SUNDRY NOTICES AND REPORTS ON WELLS
*Do not use this form for proposals to drill or to re-enter an
abandoned well. Use form 3160-3 (APD) for such proposals.*

APACHE CORP REQUEST TO CHANGE TVD & MD FOR THE NFE FEDERAL #53H
FROM: TVD: 4875' MD: 10550'
TO: TVD: 5003' MD: 10578' Landing point: 4805'

Project: Eddy County, NM (NAD27 NME)
Site: NFE Federal
Well: #53H
Wellbore: WB1
Design: Plan #3 01-30-15
Rig: TBD

Plan: Plan #3 01-30-15

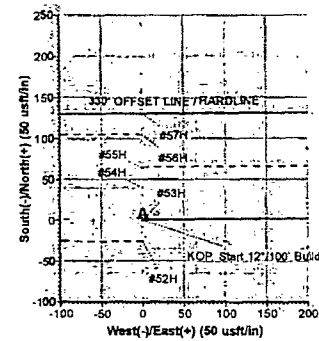
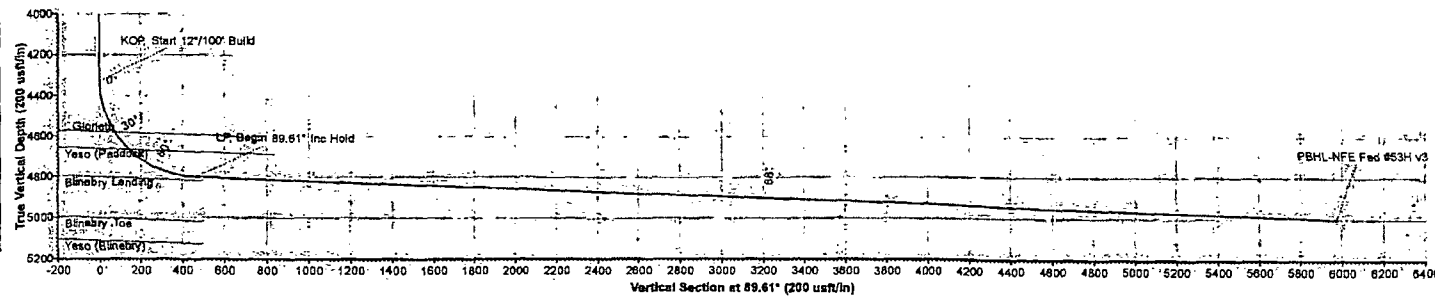
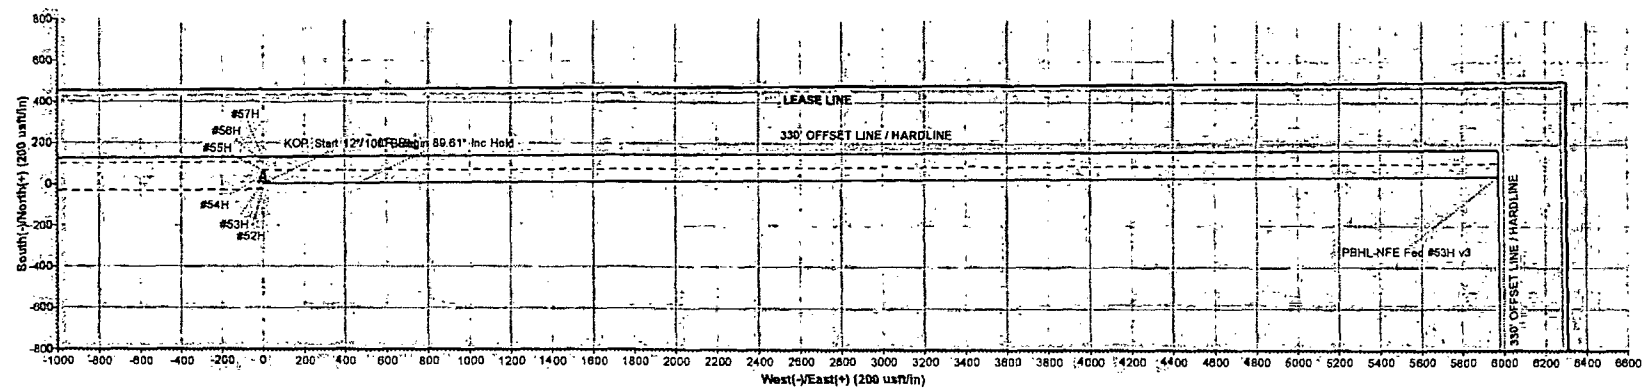
NEW DIRECTIONAL PLAN ATTACHED. NO OTHER CHANGE FROM ORIGINAL DRILLING PLAN.
